7.6 All Other Instrumentation Systems Required for Safety

The information in this section of the reference ABWR DCD, including all subsections, tables, and figures, is incorporated by reference with the following departures and supplements.

Table 7.6-4a Basic Configuration of a Typical Neutron Monitoring System Division

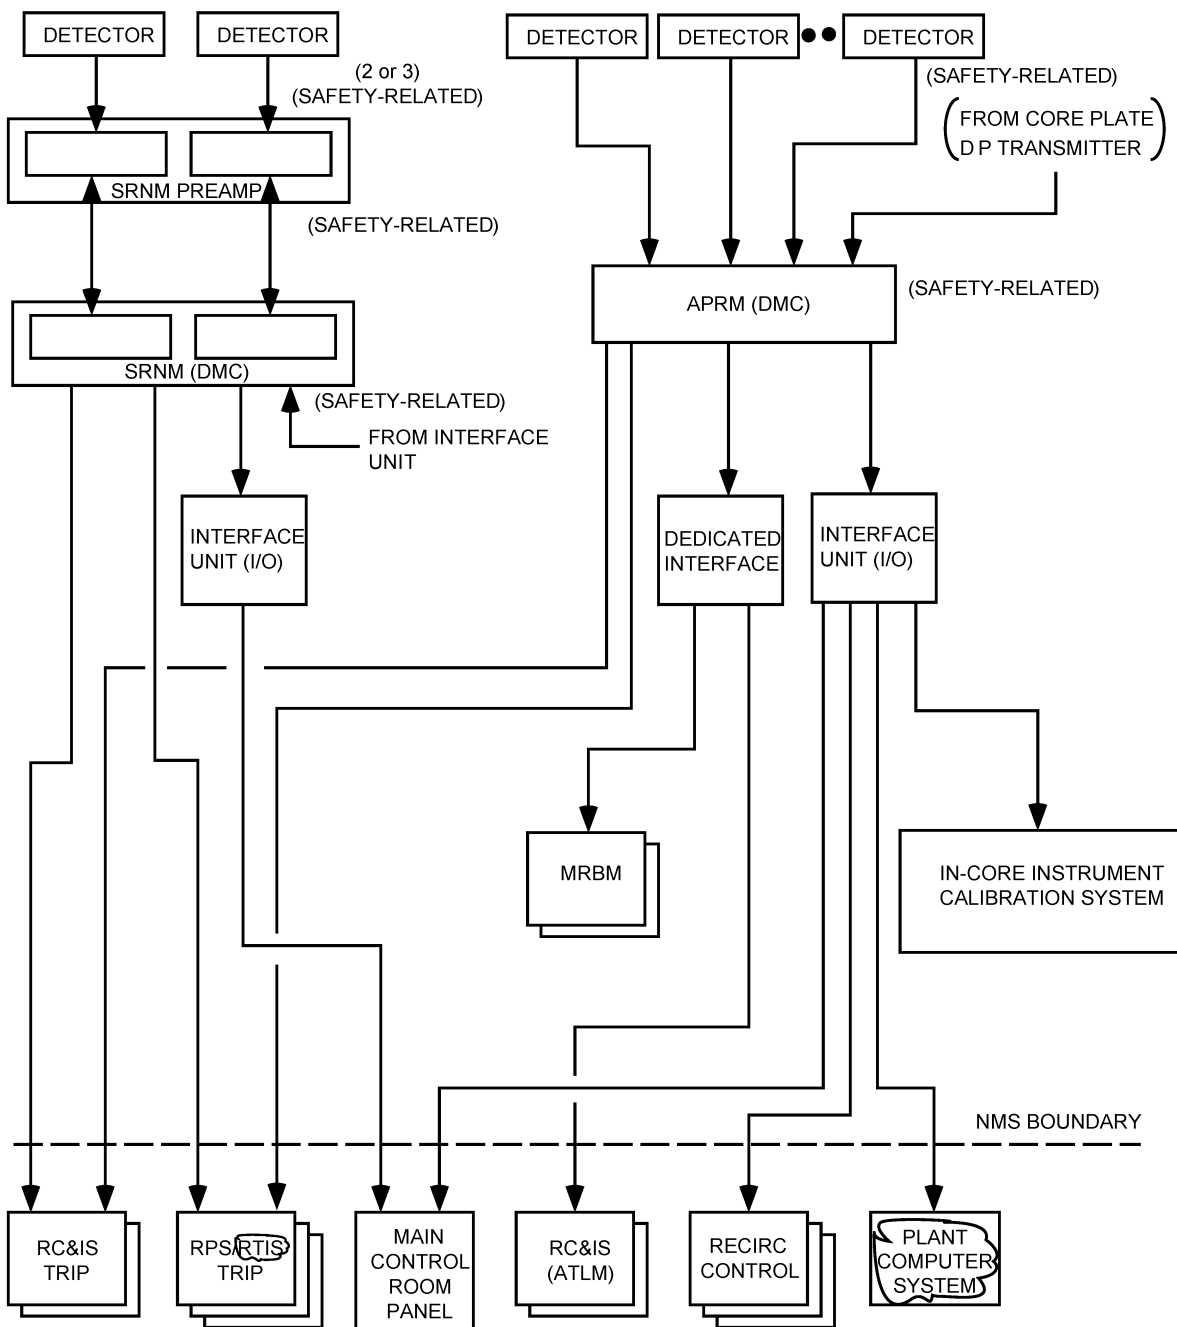
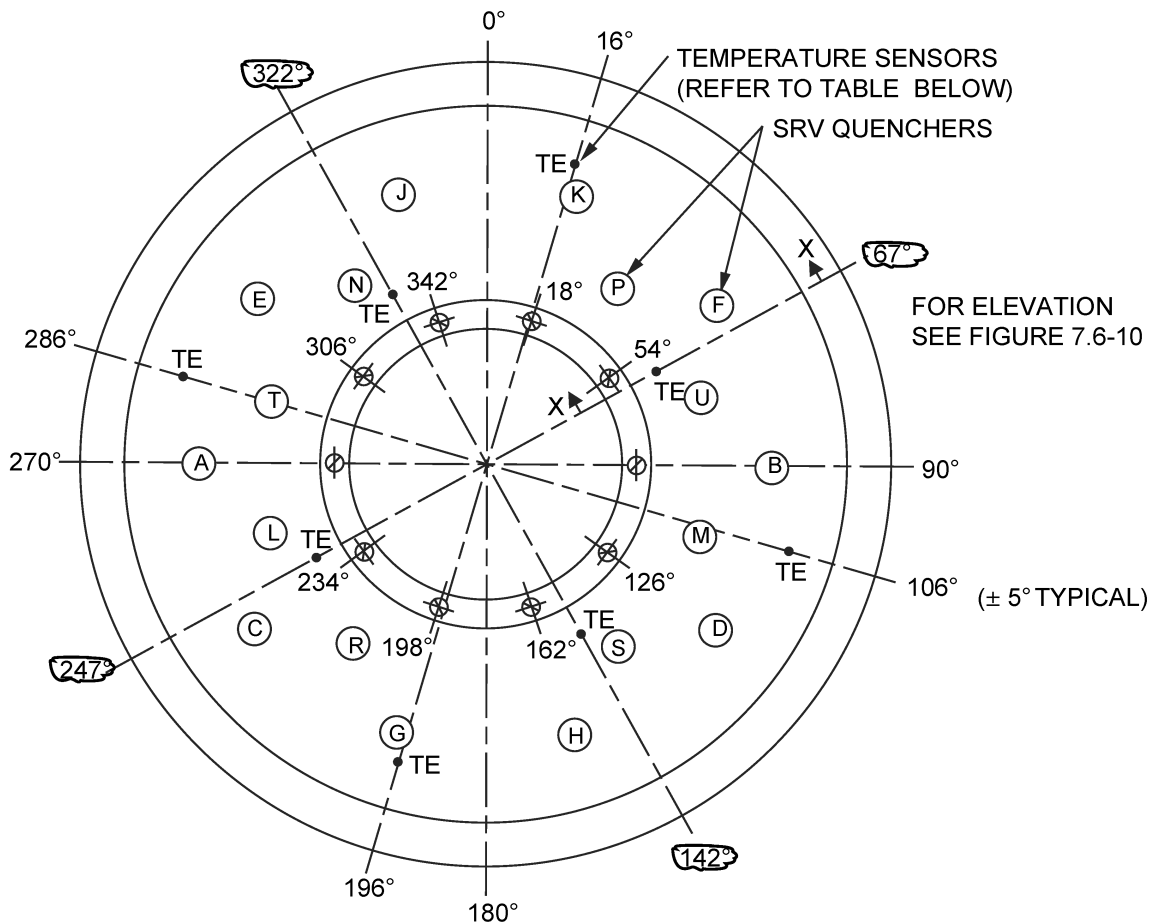
STD DEP T1 3.4-1 (Table 7.6-5 and Figures 7.6-1, 7.6-2, 7.6-4a)

The purpose of the Neutron Monitoring System (NMS) is to monitor power generation and, for the safety function part of the NMS, to provide trip signals to the Reactor Protection System (RPS) to initiate reactor scram under excessive neutron flux (and power) increase condition (high level) or neutron flux fast rising (short period) condition. The NMS also provides power information of operation and control of the reactor to the Plant Process Computer System (PCS) Functions (PCF) and the rod block monitor. A block diagram showing a typical NMS division is shown in Figure 7.6-4a. The operating ranges of the various detectors are shown in Figure 7.6-4b.

Figure 7.6-9 Instrumentation Location Definition for the Suppression Pool Temperature Monitoring System

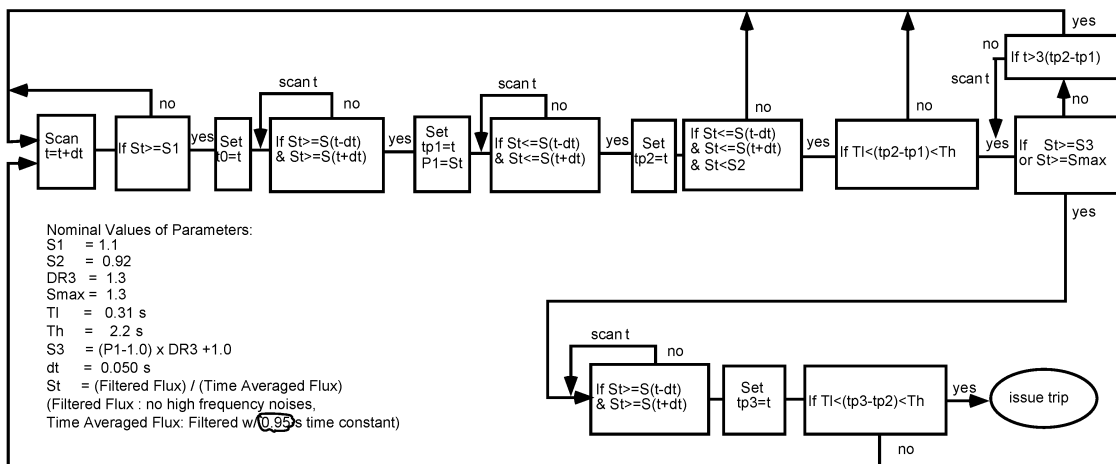
STD DEP 7.6-3 (Figures 7.6-9, 7.6-11, 7.6-12)

The SPTM System configuration is shown in Figures 7.6-9 and 7.6-10. There are eight temperature circumferential sensor locations (Figure 7.6-9), which are chosen based upon the following considerations:

- (2) Each SRV discharge line quencher is in direct sight of two sets of temperature sensors within 9 meters.

Figure 7.6-14 OPRM Logic

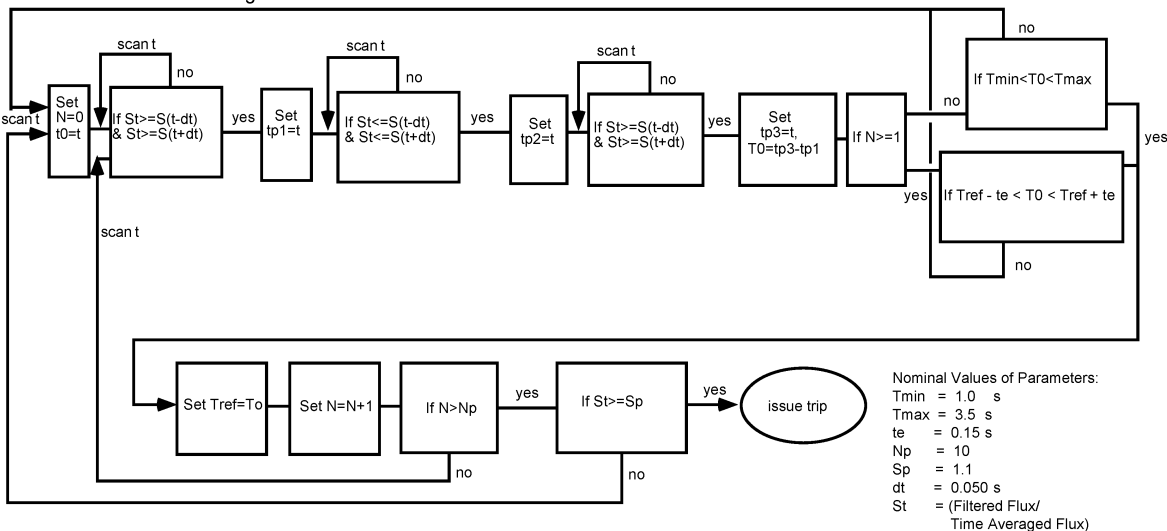
STD DEP 7.6-1 (Table 7.6-2 and Figures 7.6-2, 7.6-14)

For the OPRM trip function, the response signal of any one OPRM cell that satisfies the conditions and criteria of the trip algorithm will cause a trip of the associated OPRM channel. Figure 7.6-14 illustrates the trip algorithm logic. ~~The OPRM trip function does not have its own inoperative trip for insufficient number of total LPRM inputs in the channel. It follows the APRM's inoperative trip of insufficient number of LPRMs.~~ The OPRM function has its own inoperative trip when the channel has less than the required minimum operable cells, or there is an OPRM self-test fault, or the APRM instrument firmware/software timer has timed out, if there is a loss of power to the APRM instrument.

$T_{min}=1$ s, $T_{max}=3.5$ s, $\pm t_{error}=0.15$ s **0.1s**, $N_P=10$.
(For details see Figure 7.6-14).
